ECN/PCN No.: M1148

Product Description: Wireless Charging Coil Assembly		Abracon Part Number / Part Series: AWCCA-38R32 Series	<input checked="" type="checkbox"/> Series
Affected Revision: C	New Revision: D	Application	<input type="checkbox"/> Part Number
			<input type="checkbox"/> Safety
			<input checked="" type="checkbox"/> Non-Safety

Section 5.0 Markings

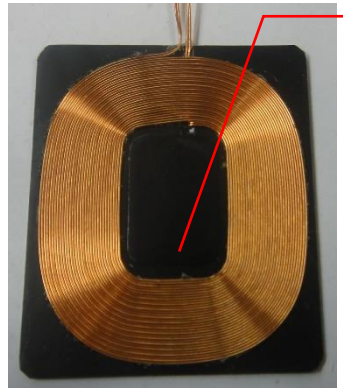
Section 5.0 Markings: None

Section 6.0 Outline Dimensions (unit mm)

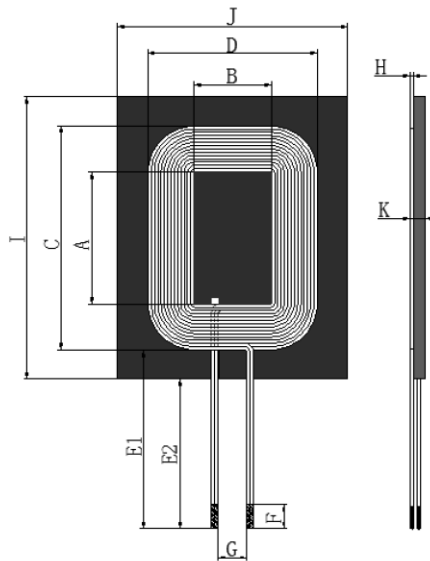
1. Dimension I: 38.5 mm +/- 1.0
2. Dimension J: 32.5 mm +/- 1.0
3. Dimension K: 1.0 mm MAX

Minor dimension change to align production to standard ferrite sheet size.

Section 6.0 Outline Dimensions (unit mm)

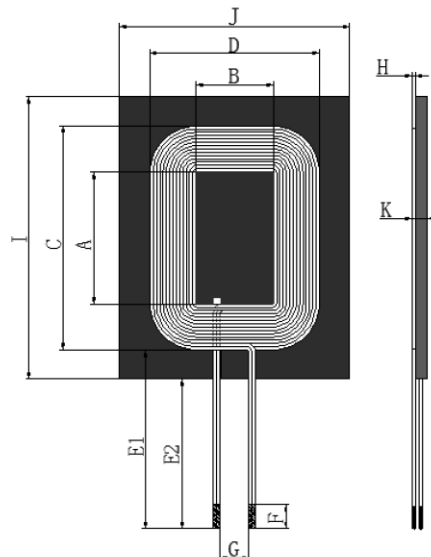
1. Dimension I: 39.0 mm MAX
2. Dimension J: 33.0 mm MAX
3. Dimension K: 1.3 mm MAX

The changes attached do not negatively impact electrical or mechanical performance of this series. The change in dimension is smaller than original while keeping the same recommended landing pattern.
